INDIANA DEPARTMENT OF TRANSPORTATION

AGENDA

February 17, 2011 Standards Committee Meeting

RE: Agenda for the February 17, 2011 Standards Committee Meeting

601-GRBS-01 GUARDRAIL AT BRIDGE SUPPORT (PROPOSED NEW, SHOWN PART 1)

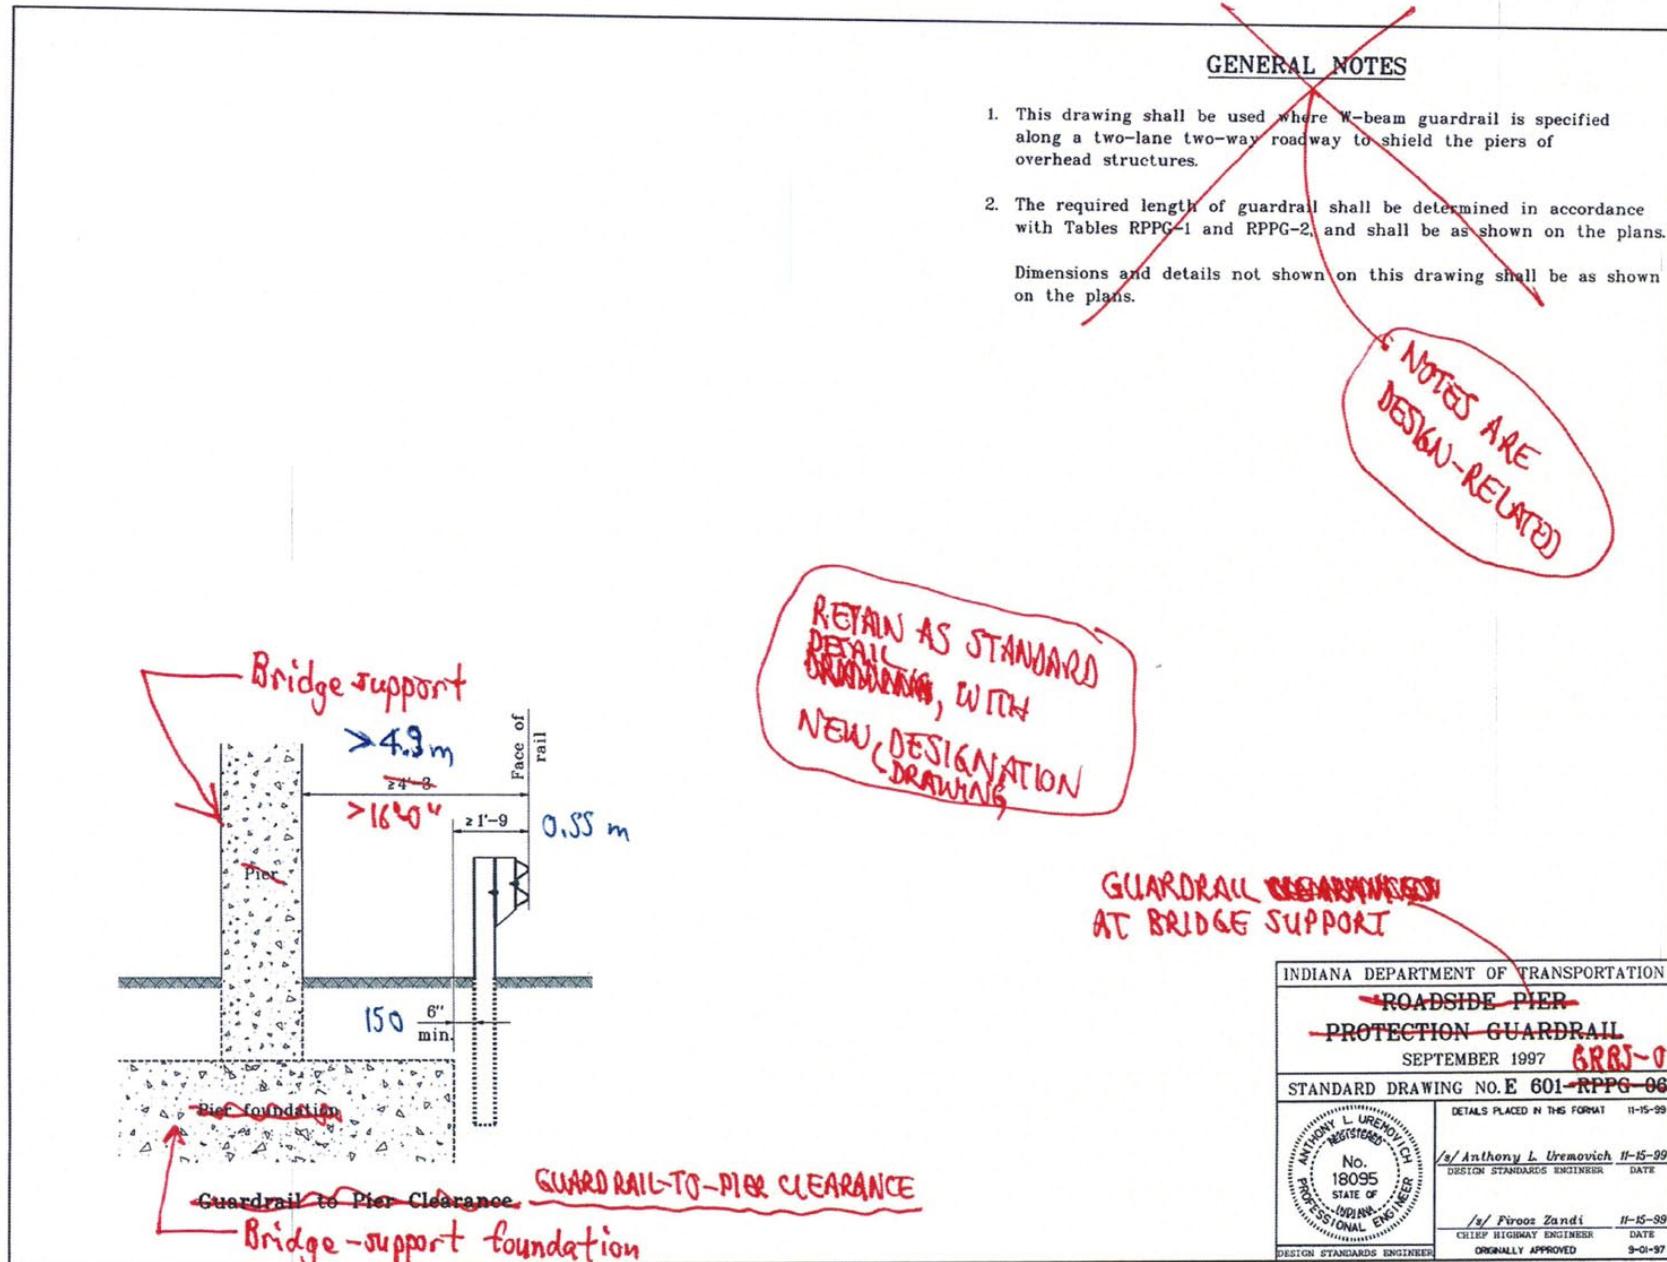
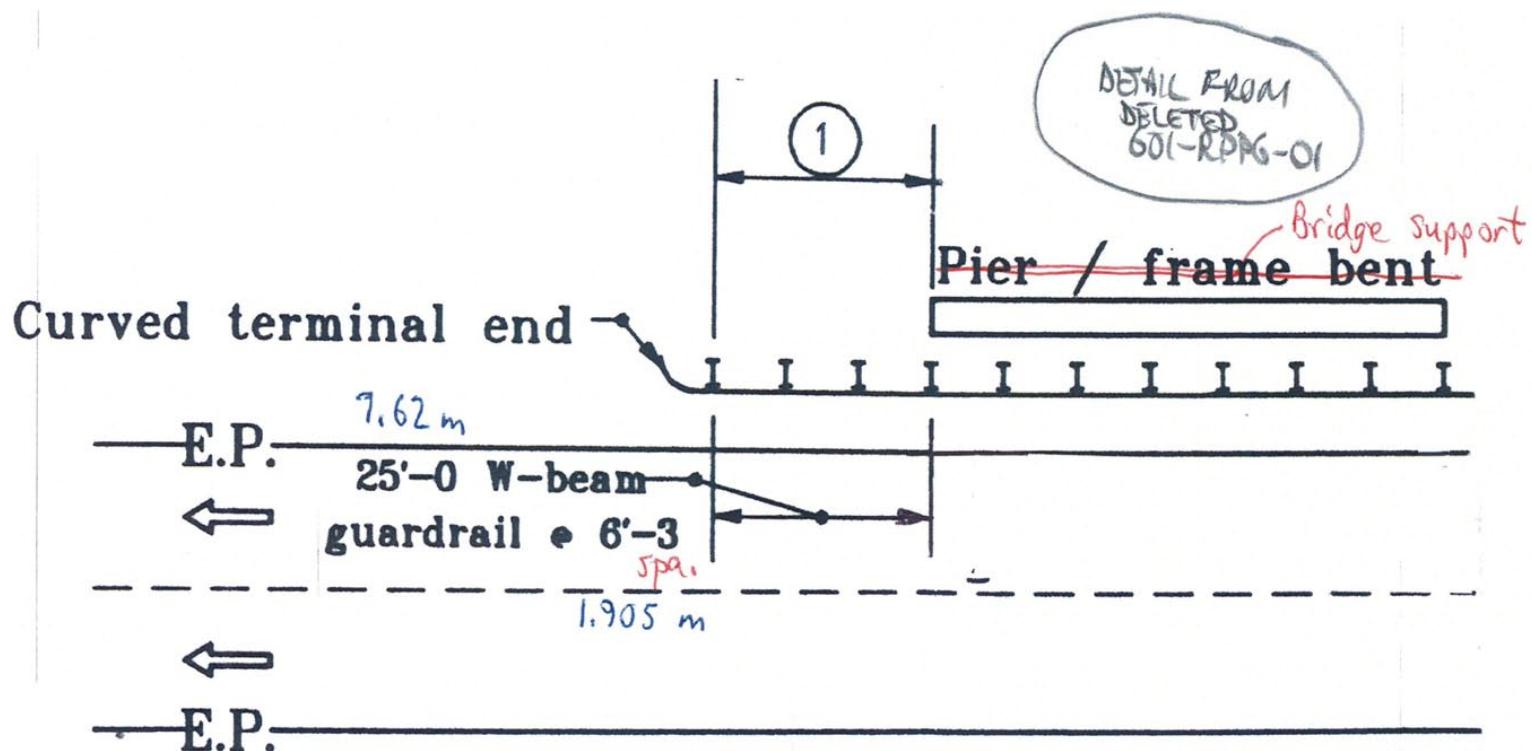
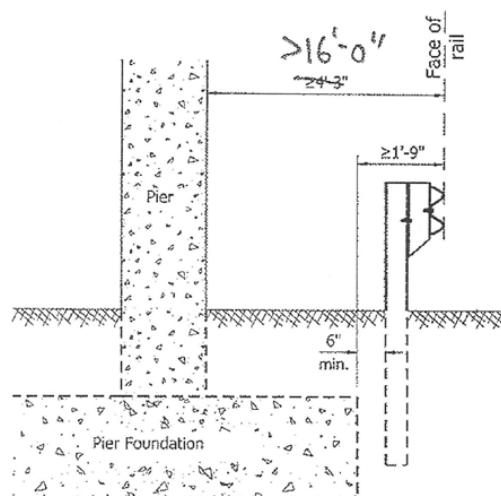
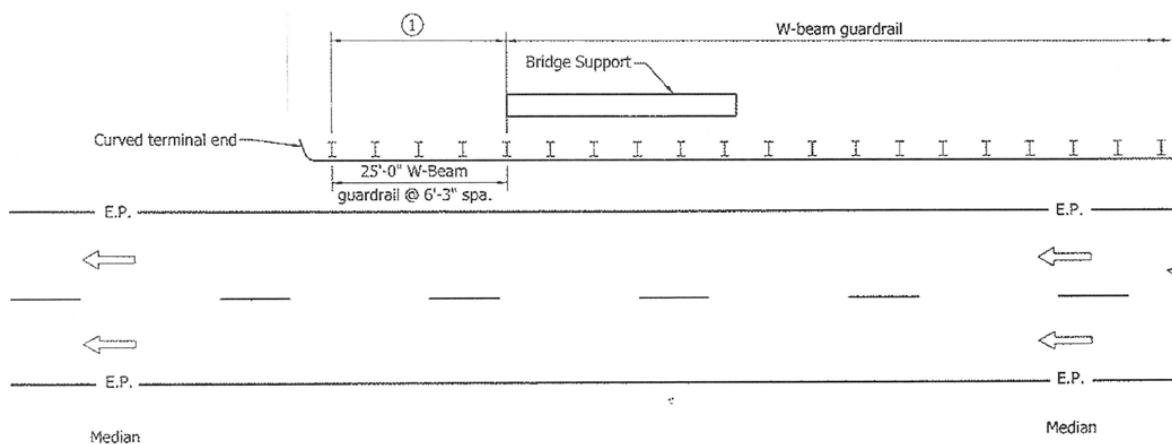
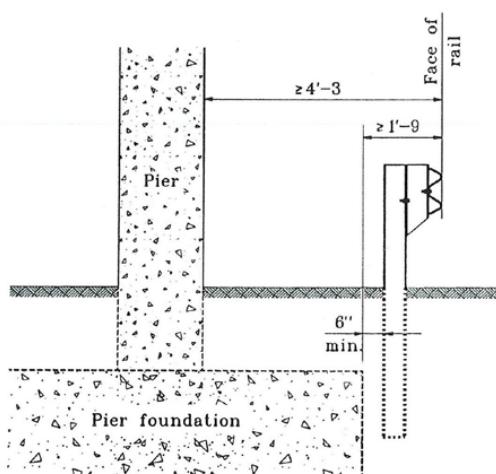
INCLUDE ON
NEW STD DWG THAT
ADDRESSES NOTE ④ ON
DWG 601-RPG-01
